# Grimes Planning and Zoning Commission

## **Planning and Zoning Commission September 22, 2022 In Person at Grimes Community Complex, 410 SE Main Street, Room 202**

TO: Planning and Zoning Commission  
FROM: Molly Mannel, Assistant Planner  
DATE: September 6, 2022  
RE: Rock Creek Plat 1 – Preliminary Plat

TO: Planning and Zoning Commission  
FROM: Molly Mannel, Assistant Planner  
DATE: September 6, 2022  
RE: Rock Creek Building 1 – Site Plan

1 TRASH ENCLOSURE PLAN  
SCALE: 1/4" = 1'-0"

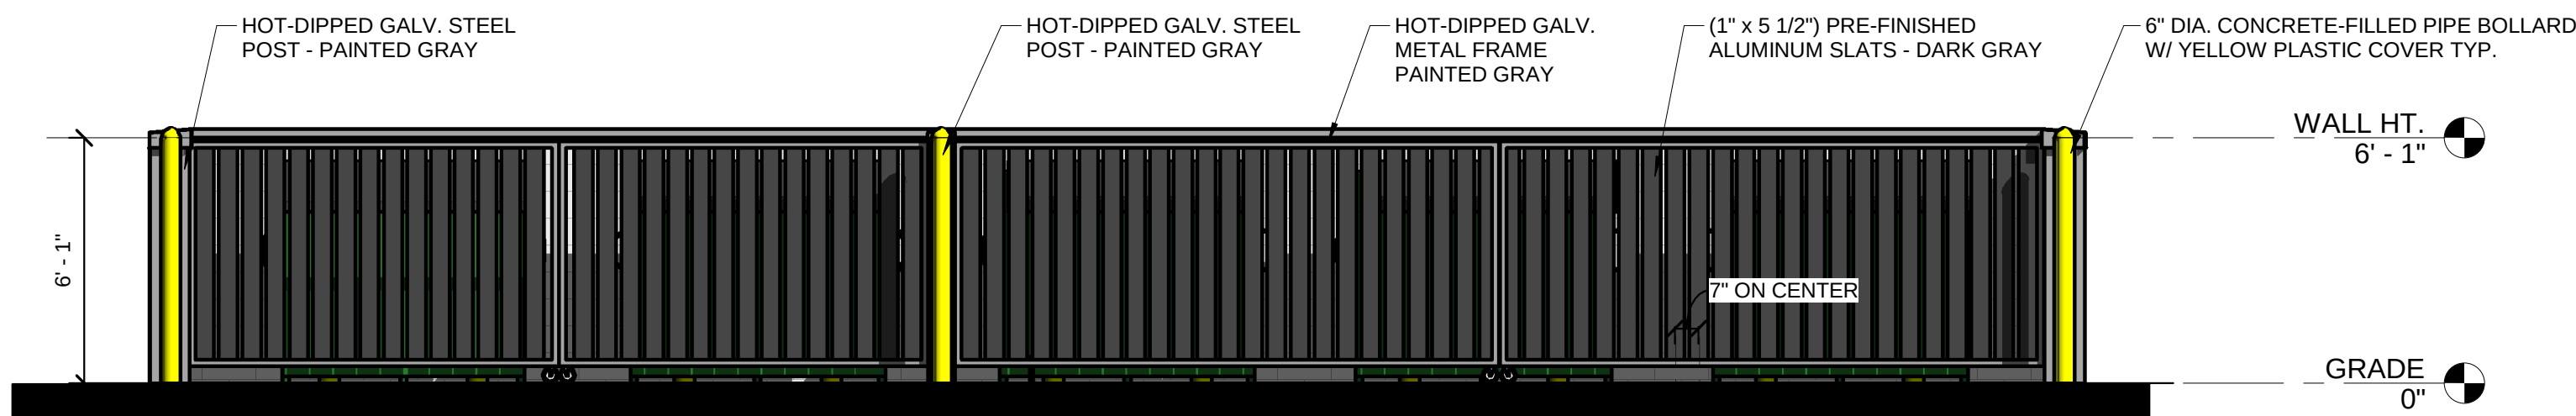
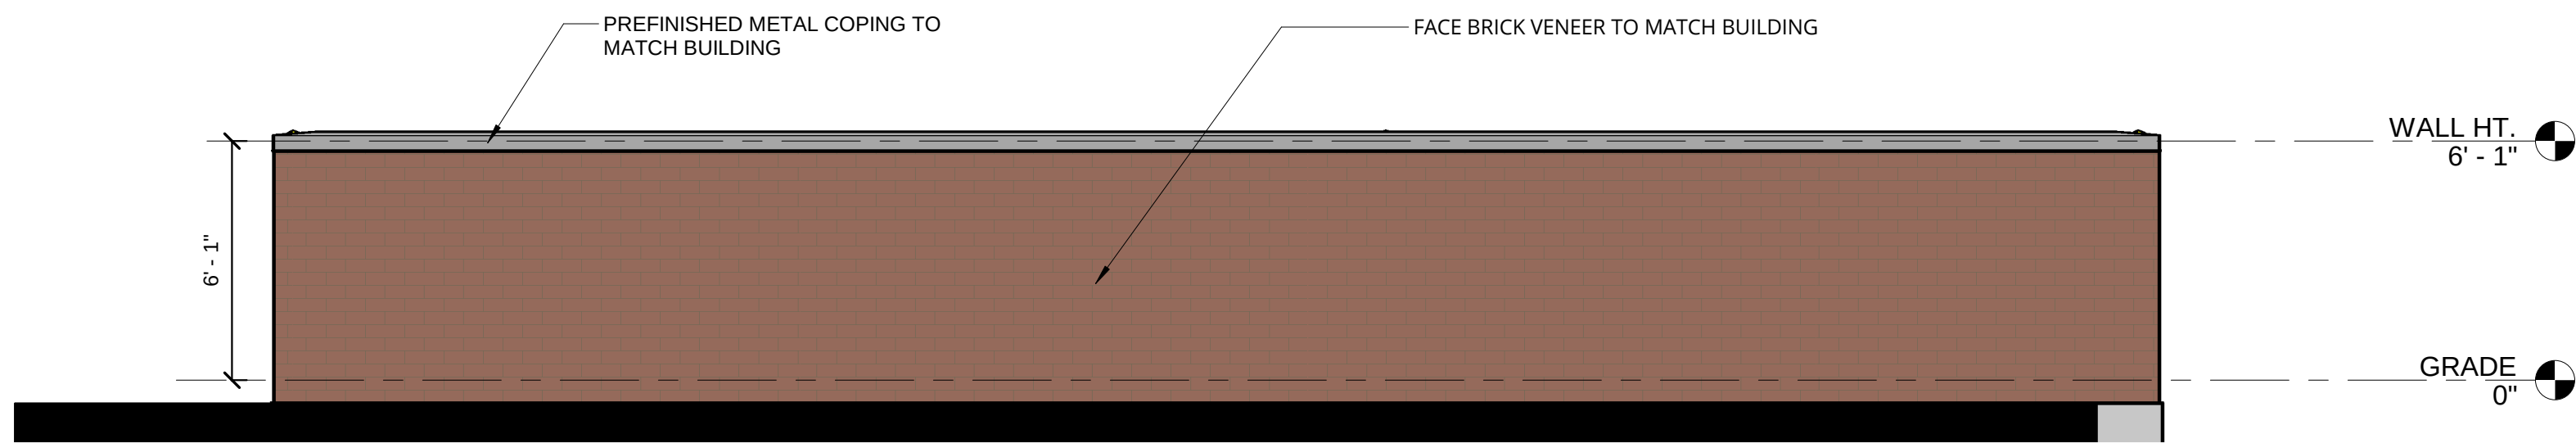
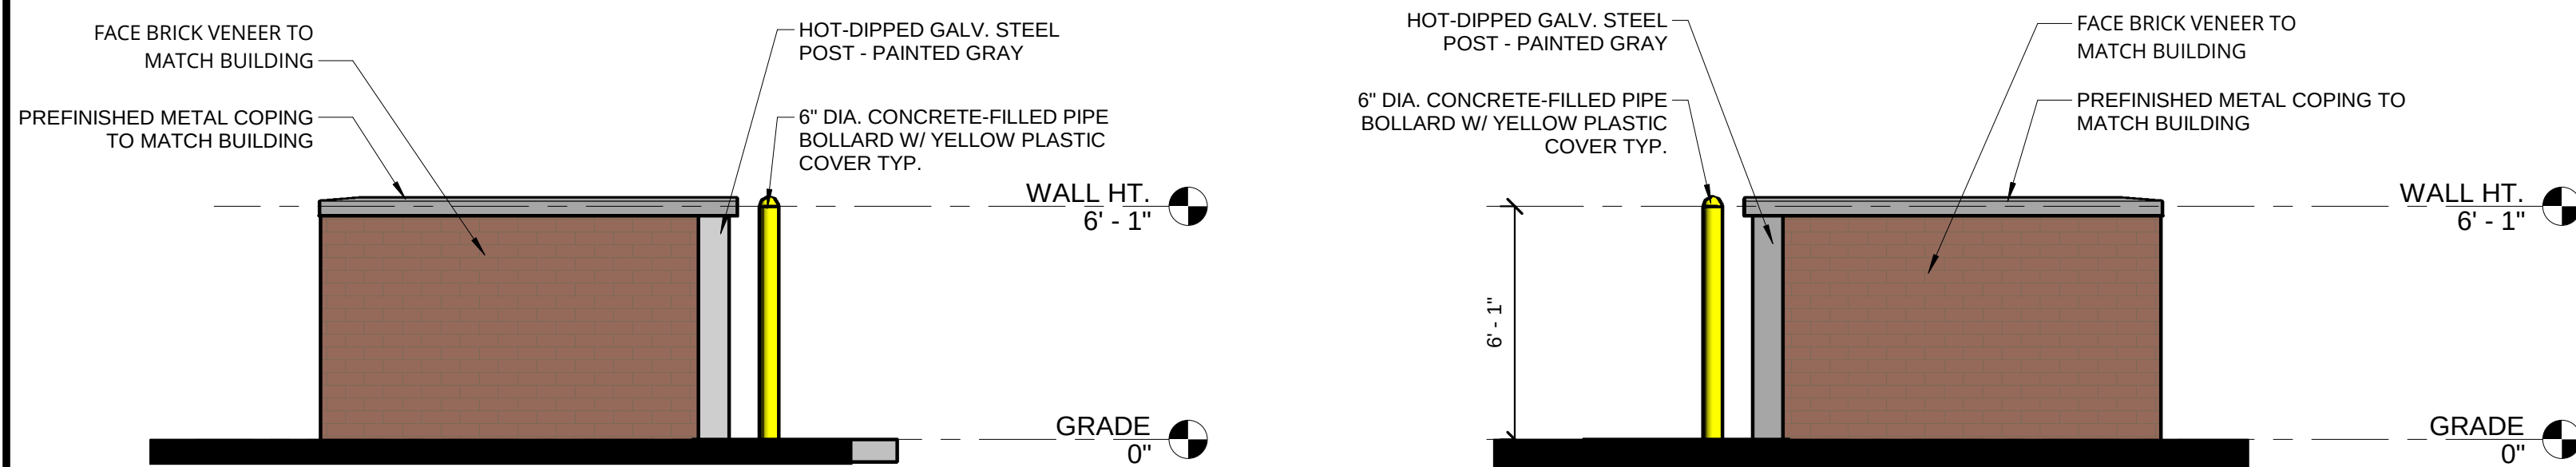
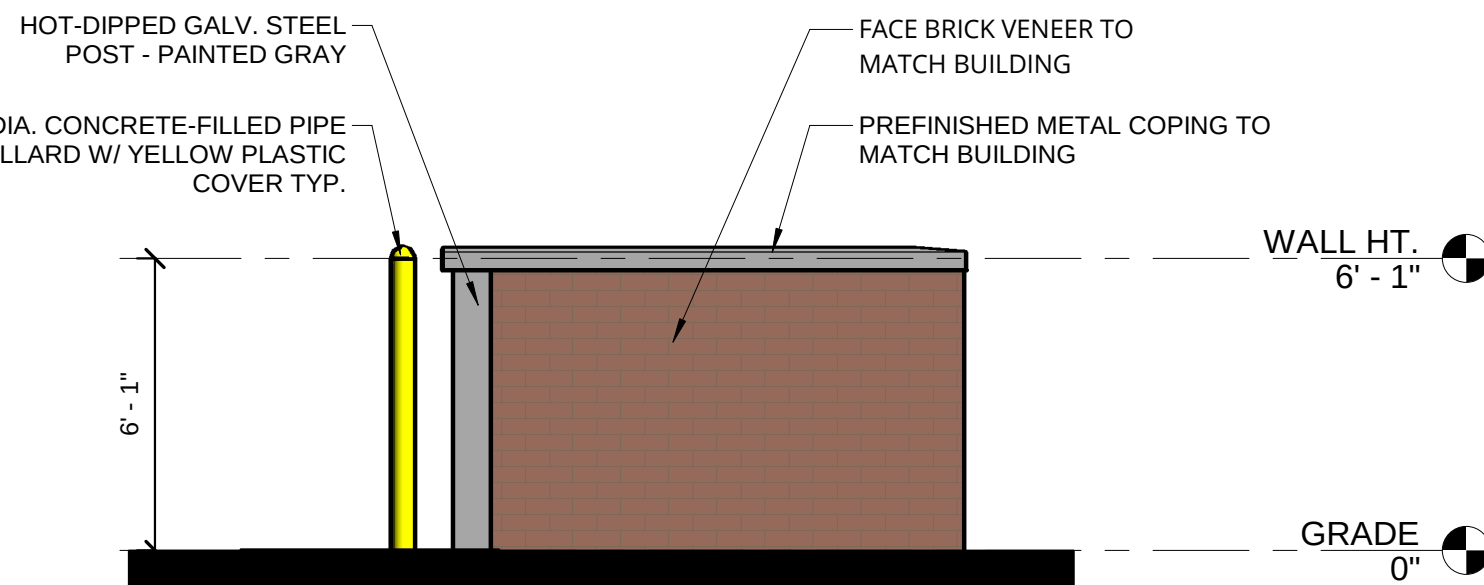
1. Please provide the elevations for the physician parking canopy cover. Please provide a concept.
- ~~2. Please provide material calculations/percentages for each side of the building.~~
- ~~3. Provide building material labels/details.~~
- ~~4. Please widen the brick edge on the NW corner.~~
- ~~5. Staff questions why spandril is being used. Please explain.~~
6. Provide dumpster enclosure details. Please provide.

6 EQUIPMENT SCREEN PLAN  
SCALE: 1/8" = 1'-0"

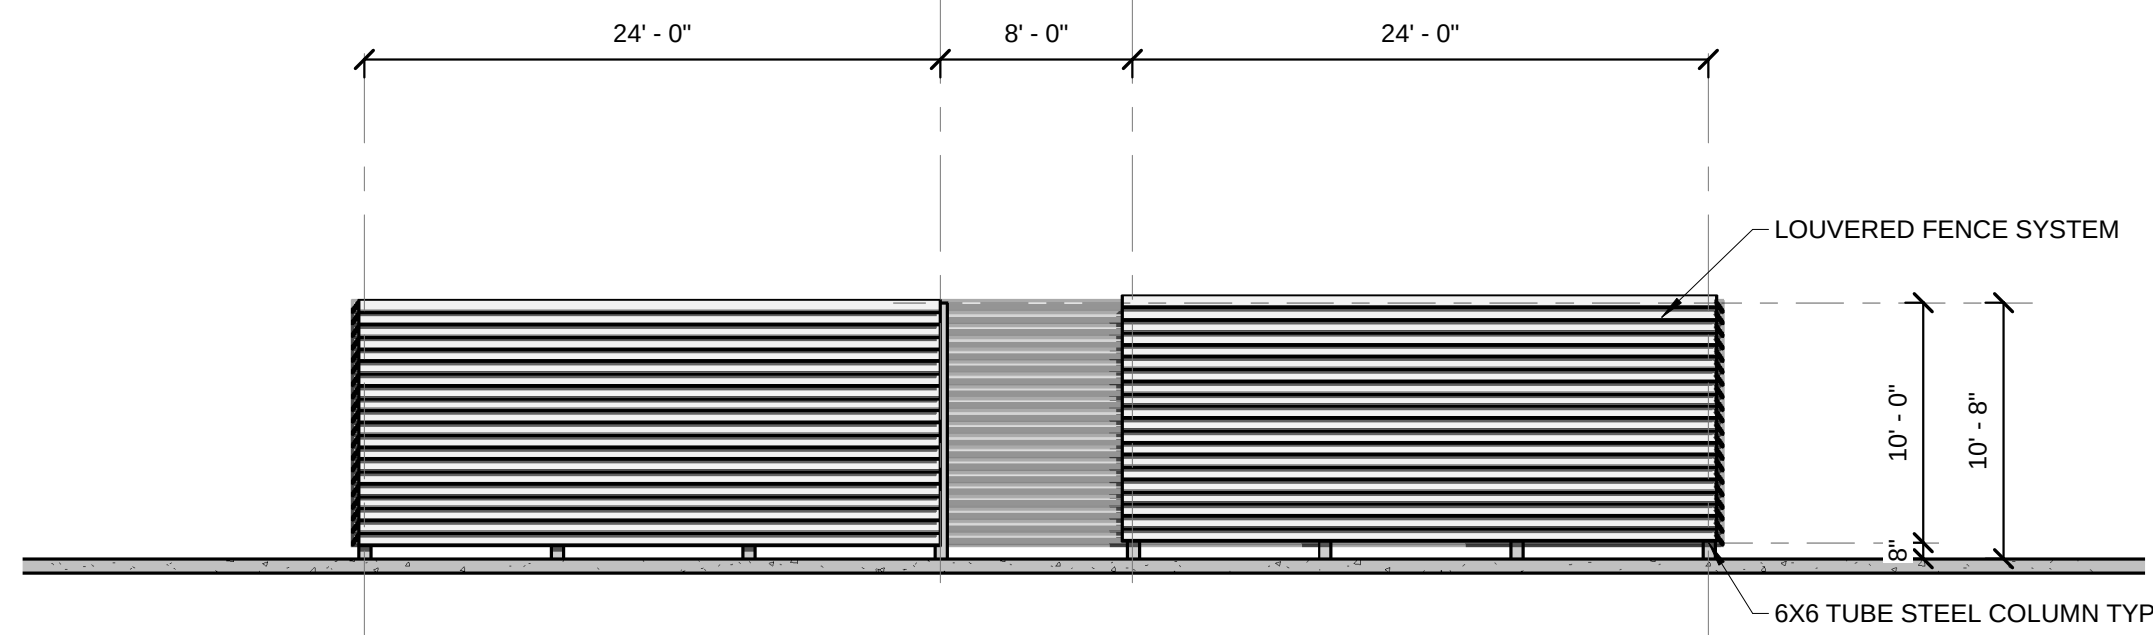
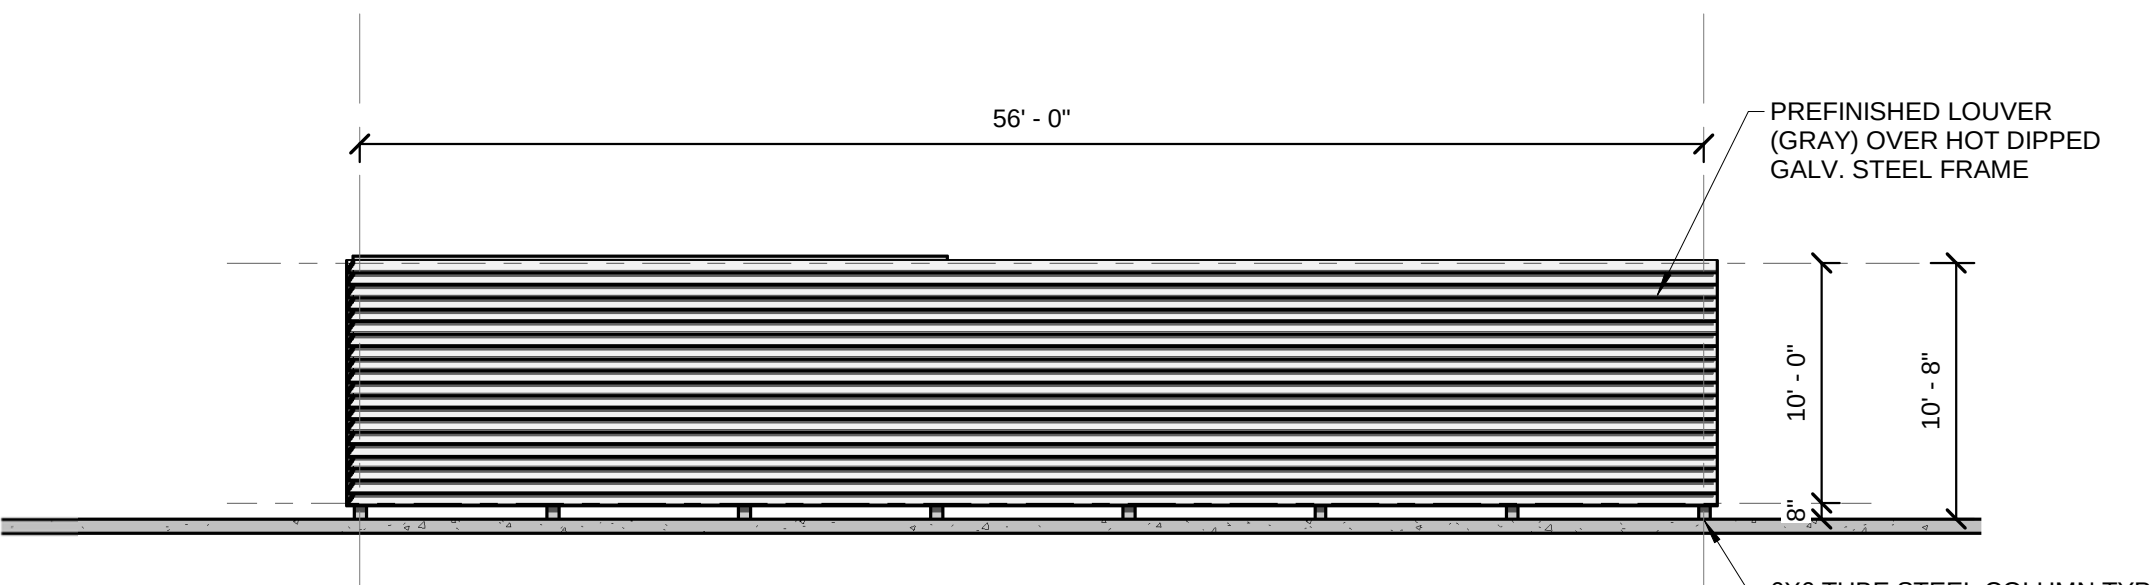
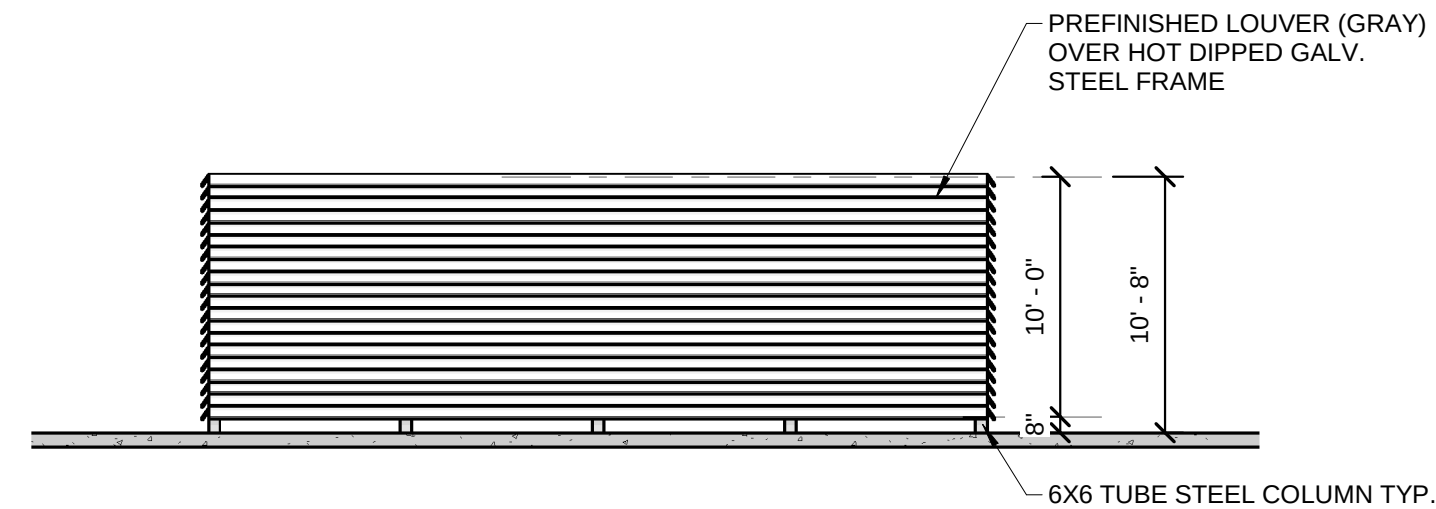
7. Provide generator/chiller screening elevations. Please provide.
8. On the NW corner of the building, please extend brick up to the parapet and then extend roof line up to provide more roof articulation. This will enhance the corner and break up the plane of niches. Staff prefers this – architect has made note via Zoom discussion.
9. ~~Is this pattern the pattern you are going to build? We expect the elevation to match the final construction.~~
10. Staff questions how the 40% of the building façade length along the ROW is being met. Please ensure 40% of the building length is glazing.
11. ~~Based on the material provided, a 4/5 vote of approval is required by council.~~
